AGENDA PACKET PART 3 of 3

JUNE 19, 2018 MEETING

Sprint Spectrum at Leon Levy Preserve, 1411 Route 35, South Salem, NY 10590, Sheet 11, Block 11137, Lots 35 and 52 (Town of Lewisboro, owner of record) – Application for Sprint equipment upgrade at Leon Levy Preserve.

Verizon Wireless at 117 Waccabuc Road, Goldens Bridge, NY 10526, Sheet 11, Block 11137, Lots 35 and 52 (Francis Coyle, owner of record) - Application for Verizon equipment upgrade and Special Use Permit renewal.

PROJECT 35469
SHEET A-3

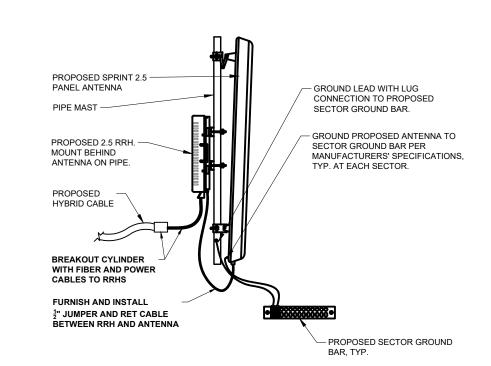
- 1. In order to determine if the application can be considered exempt, the volume calculation required per Section 220-41.1H(1)(a) of the Zoning Code shall be submitted.
- 2. The proposed panel antennas shall be dimensioned on Sheet A-3 of the site plans.
- 3. A Radio Frequency Compliance Report shall be submitted for review.
- 4. If the proposed action is deemed to require a Special Use Permit from the Planning Board, the Short Environmental Assessment Form (EAF) shall be prepared by the applicant and submitted for review (Parts 1 and 2).

TITLE SHEET WACCABUC 117 WACCABUC ROAD GOLDENS BRIDGE, NY 10526 8121.WACCABUC T-1

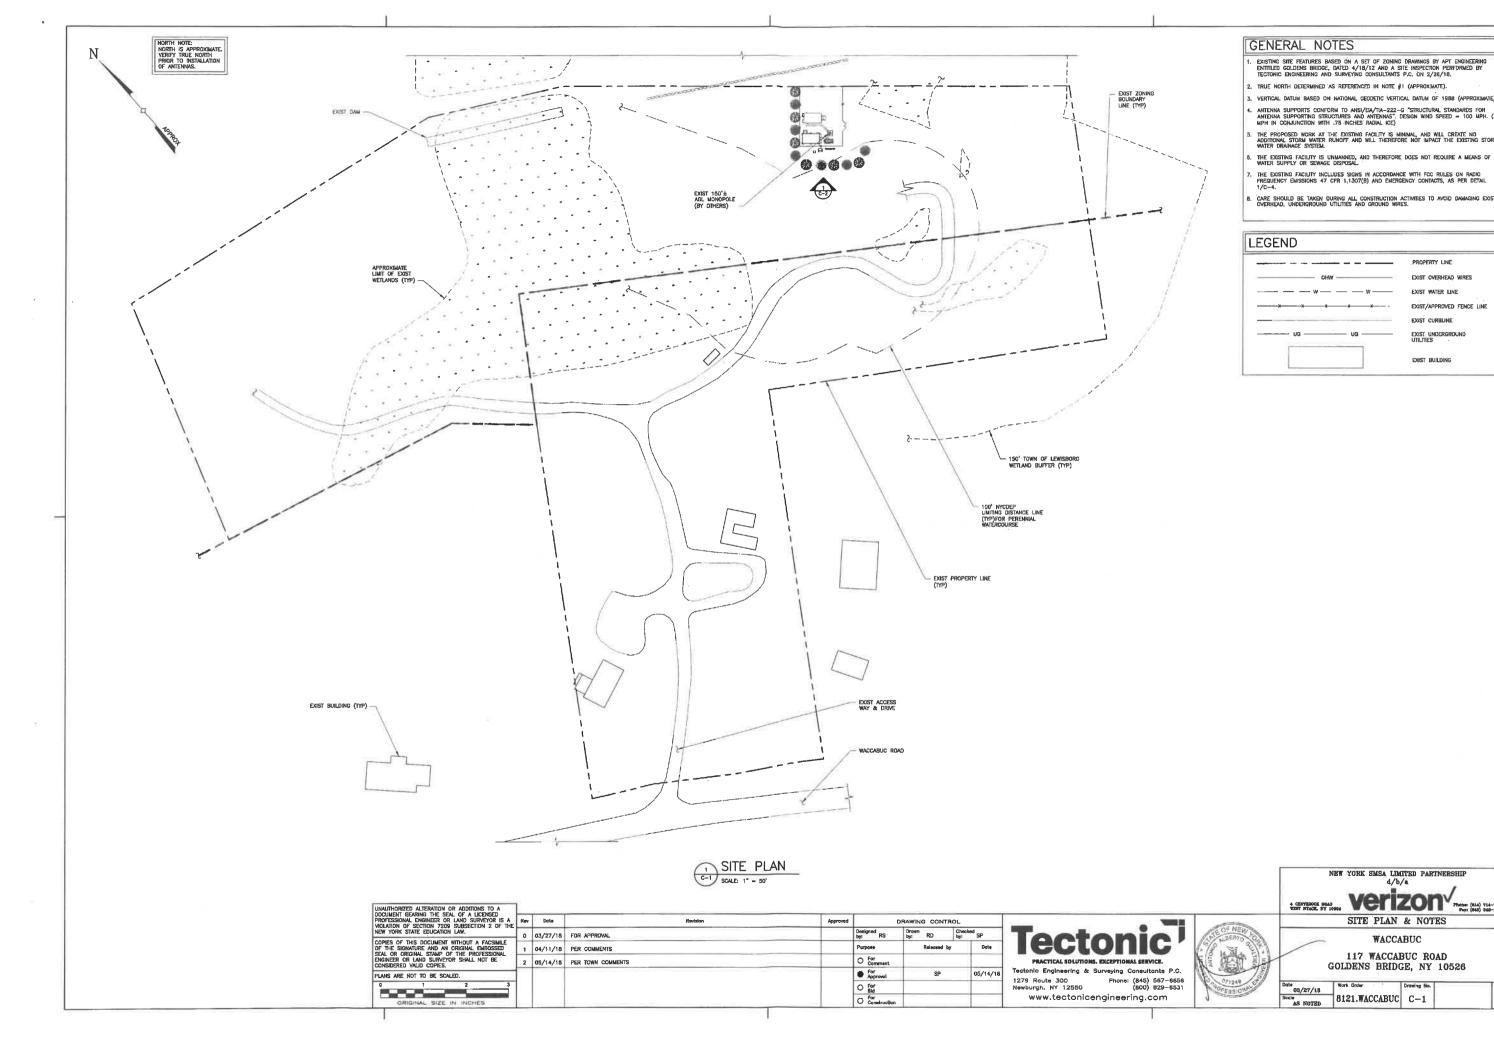
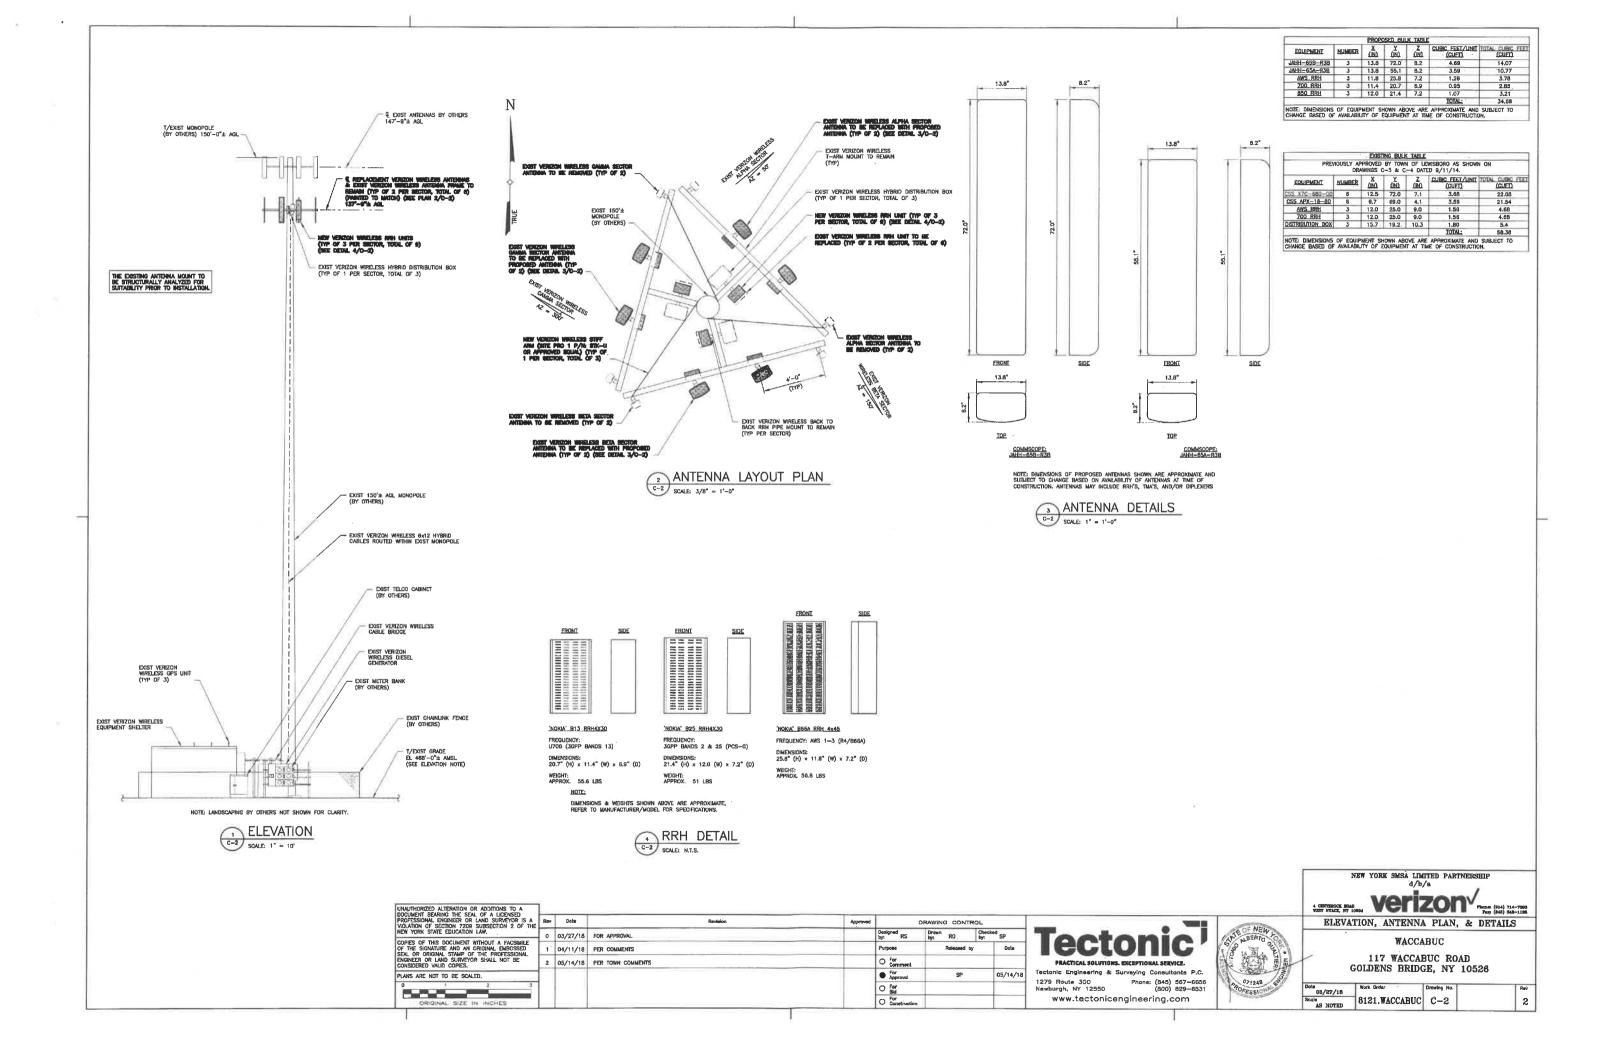
Comment #4: The submitted structural analysis states that the application involves the removal of 12 existing panel antennas, while the submitted site plan calls for the removal of six {6} existing antennas; this apparent discrepancy shall be resolved. Further, the structural report should clarify the ramifications of the statement that the existing T-Arm does not meet the minimum requirements for classification and therefore cannot be classified per the NSTD standard.

<u>Comment #5:</u> The structural report makes specific recommendations to be incorporated into the design; these recommendations shall be identified or noted on the submitted plans.

Response: Please note that both the structural report prepared by Tectonic, dated, April 6, 2018, ("Structural") and the Plans provide for the same Antenna Work. The Plans indicate that six (6) of the twelve (12) antennas are to be removed and the remaining six (6) of the twelve (12) antennas are to be replaced/upgraded. The Structural indicates that all twelve existing antennas are to be removed and six new antennas are to be installed. In both descriptions, all twelve existing antennas are to be removed with only six (6) of them being replaced.

Response: Attached hereto, please find revised plans, dated May 14, 2018, prepared by Tectonic, which shows the "stiff-arm[s]" noted in the Structural.
